MECHANICAL		P&ID	
GASEOUS RADWASTE - RECOMBINATION (UNIT 2)			
LIMERICK GENERATING STATION EXELON NUCLEAR CORP.			
SCALE	DRAWN	IGDS	CHECKED
1"=10'	BECHTEL	BECHTEL	BECHTEL
APPROVED	BECHTEL	APPROVED	BECHTEL

SHEET 3 OF 20 CATEGORY A1

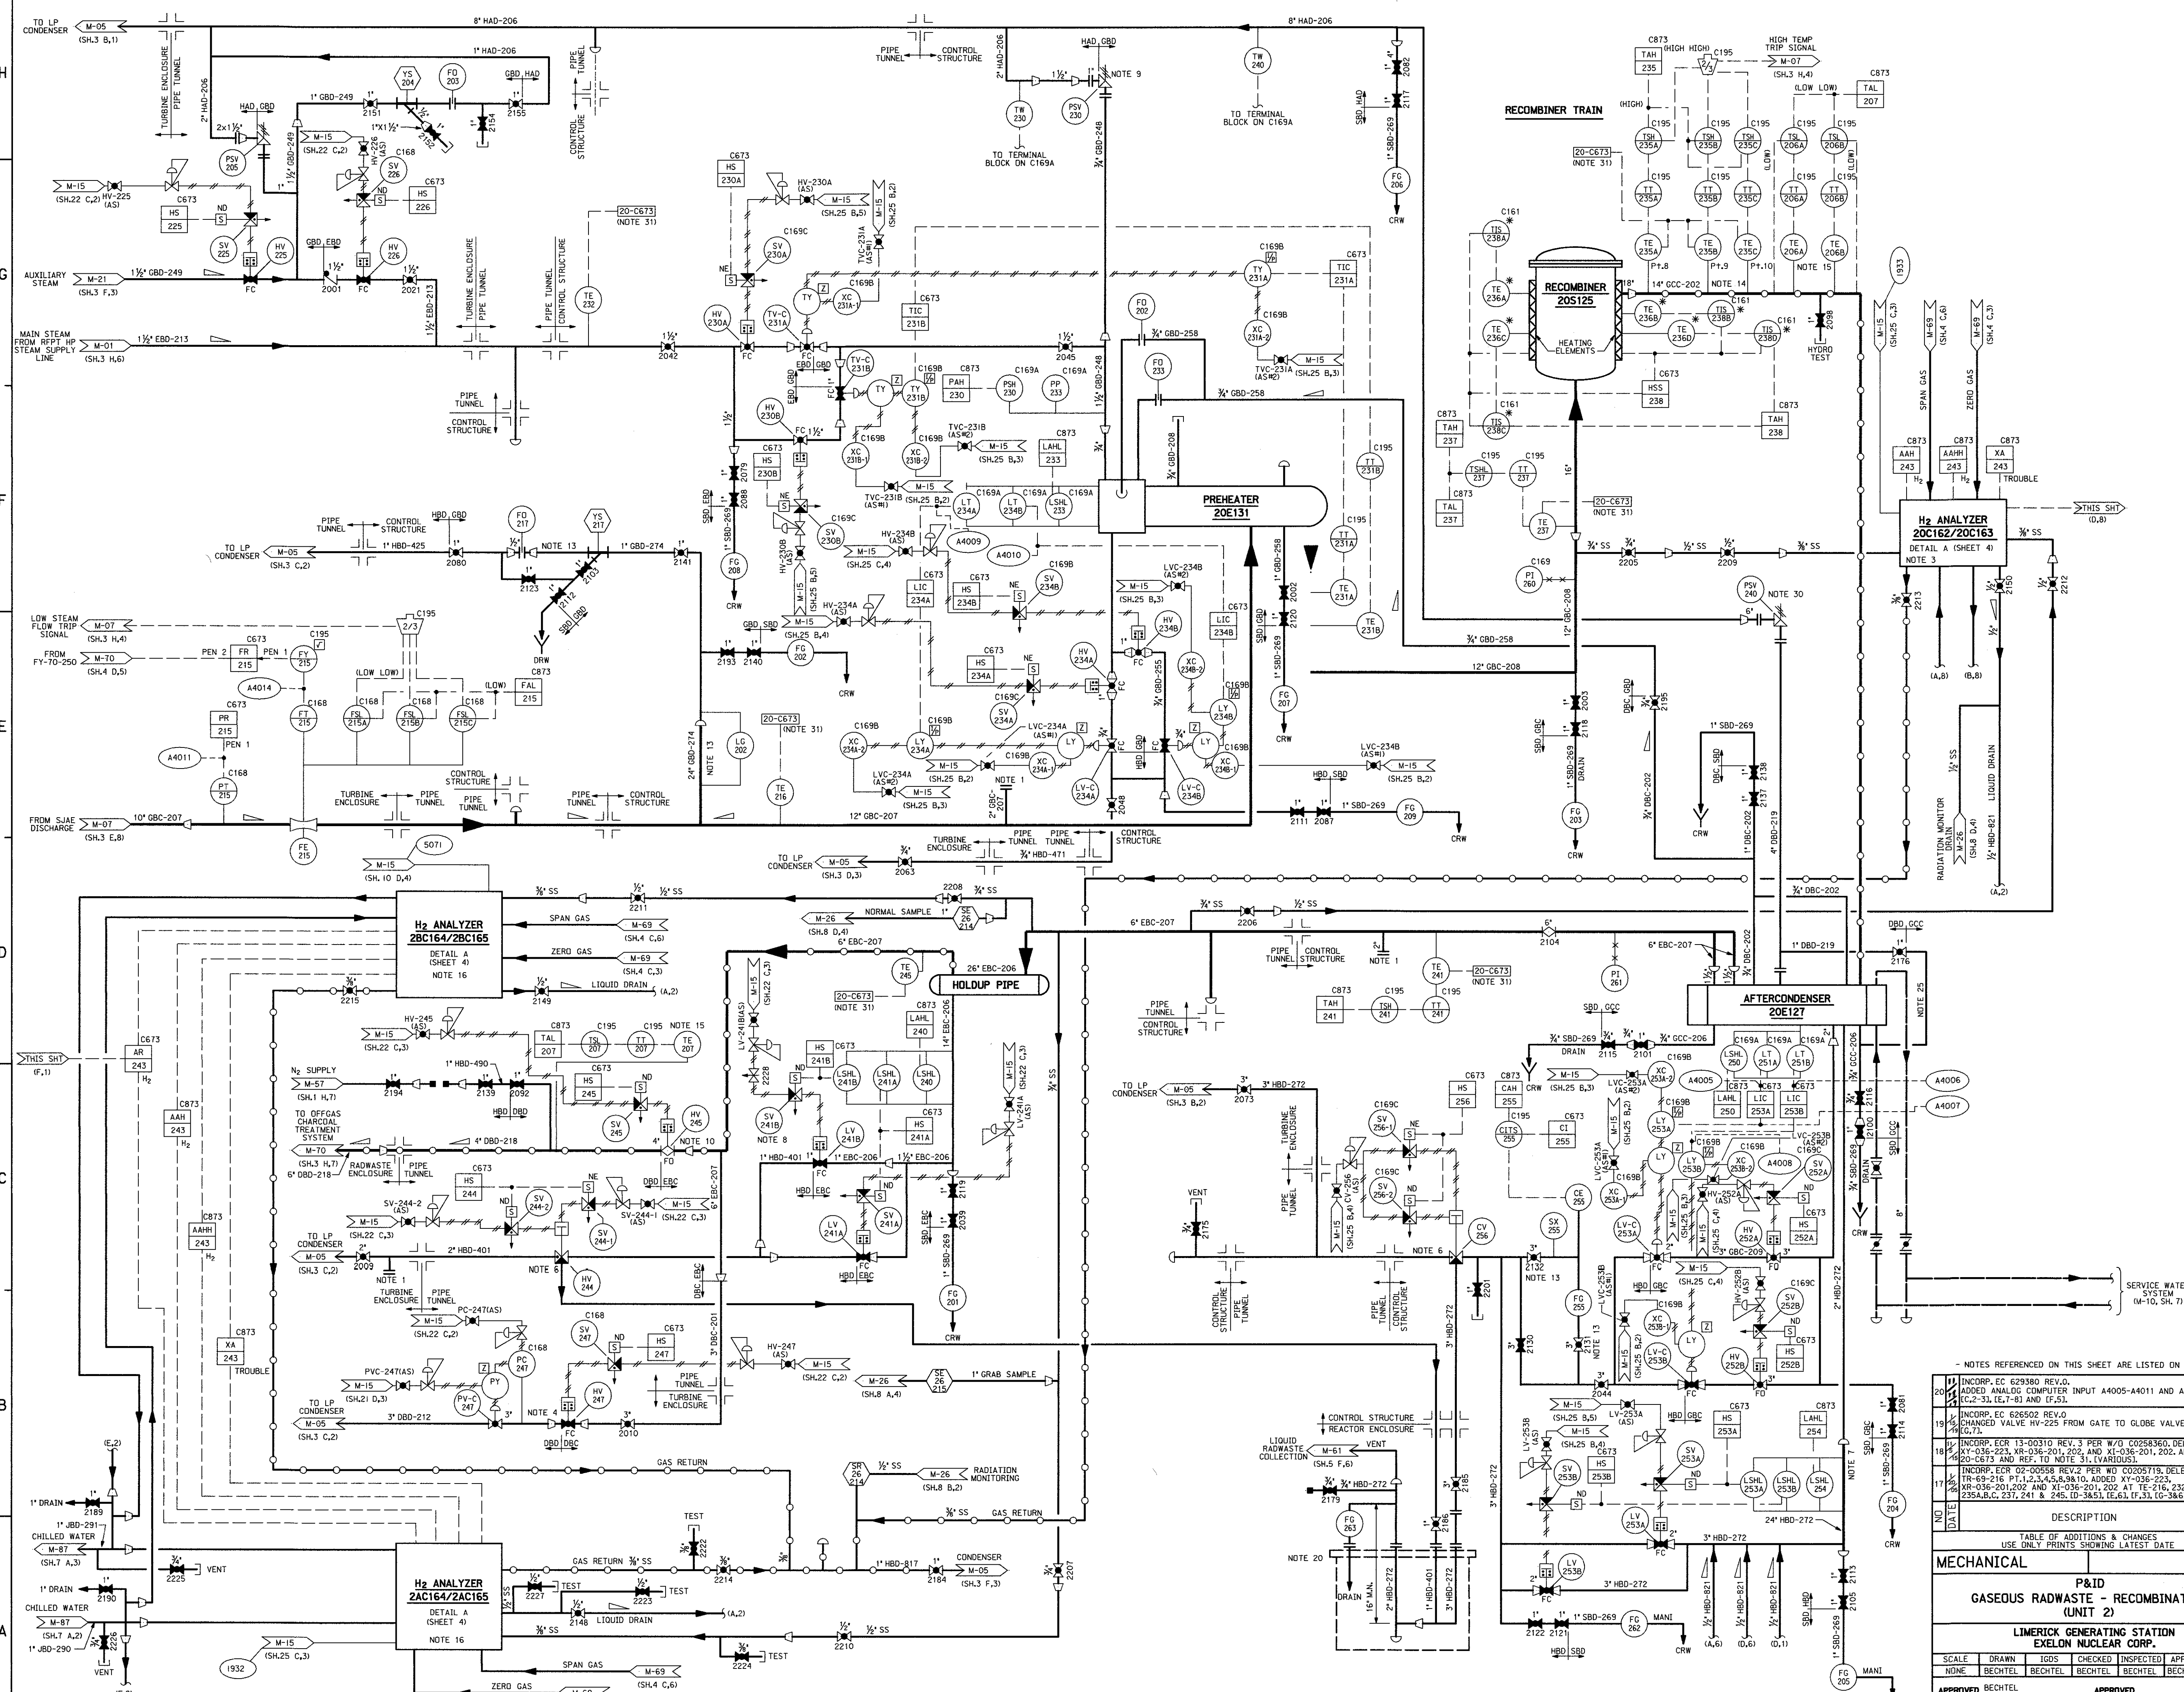
- INCORP. EOR 629380 REV. Q, ADDED ANALOG COMPUTER INPUT A4005-A4011 AND A4014 (E.C.2-31, E.7-83 AND F.51).
- INCORP. EOR 626502 REV. Q, CHANGED VALVE HV-225 FROM GATE TO GLOBE VALVE. (E.C.1).
- INCORP. EOR 13-00310 REV. 3 PER W/O C0258360, DELETED (E.C.1).
- INCORP. EOR 02-00558 REV.2 PER W/O C0205719, DELETED (E.C.1).
- INCORP. EOR 02-00558 REV.2 PER W/O C0205719, DELETED (E.C.1).
